Following please find MARKED UP VERSIONS OF CLAIMS 2, 3 and 11-13 showing all changes made relative to the previous version of those claims -

REMARKS

FIG. 3

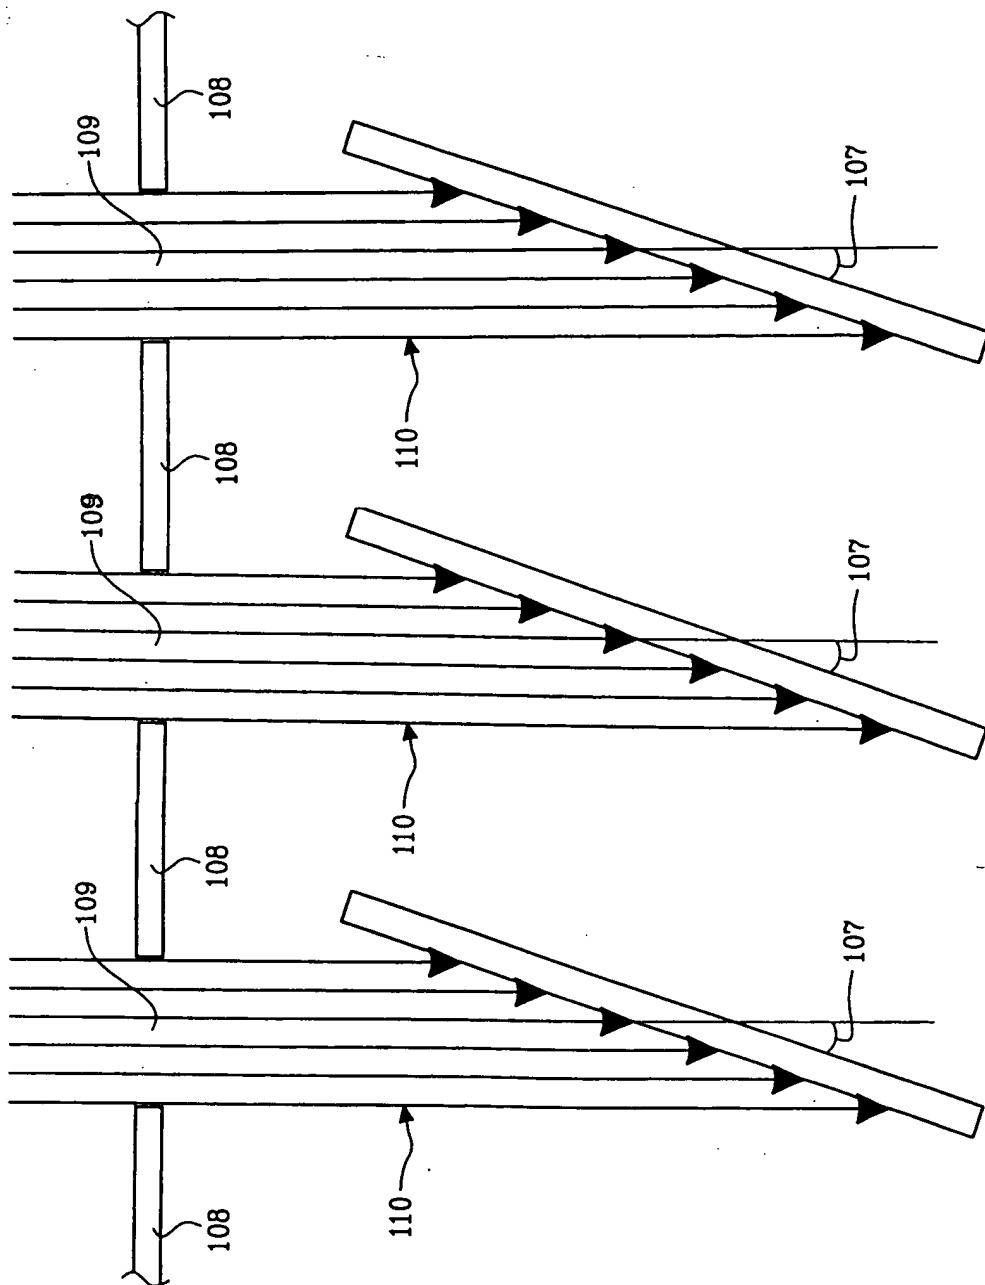
The drawings must show every feature of the invention specified in the claims. Therefore, the apparatus comprising several detectors [*sic*, detectors], each having a collimator (claim 7) must be shown or the feature(s) canceled from the claim(s).

Attached hereto is proposed new Figure 3 for the Examiner's approval. Support for this proposed Figure is found in paragraph 0028 of the Specification. Accordingly, no new matter is added with this Figure. It is believed that the proposed amendments overcome the objection to the drawings. Withdrawal of the objection to the drawings is respectfully requested.
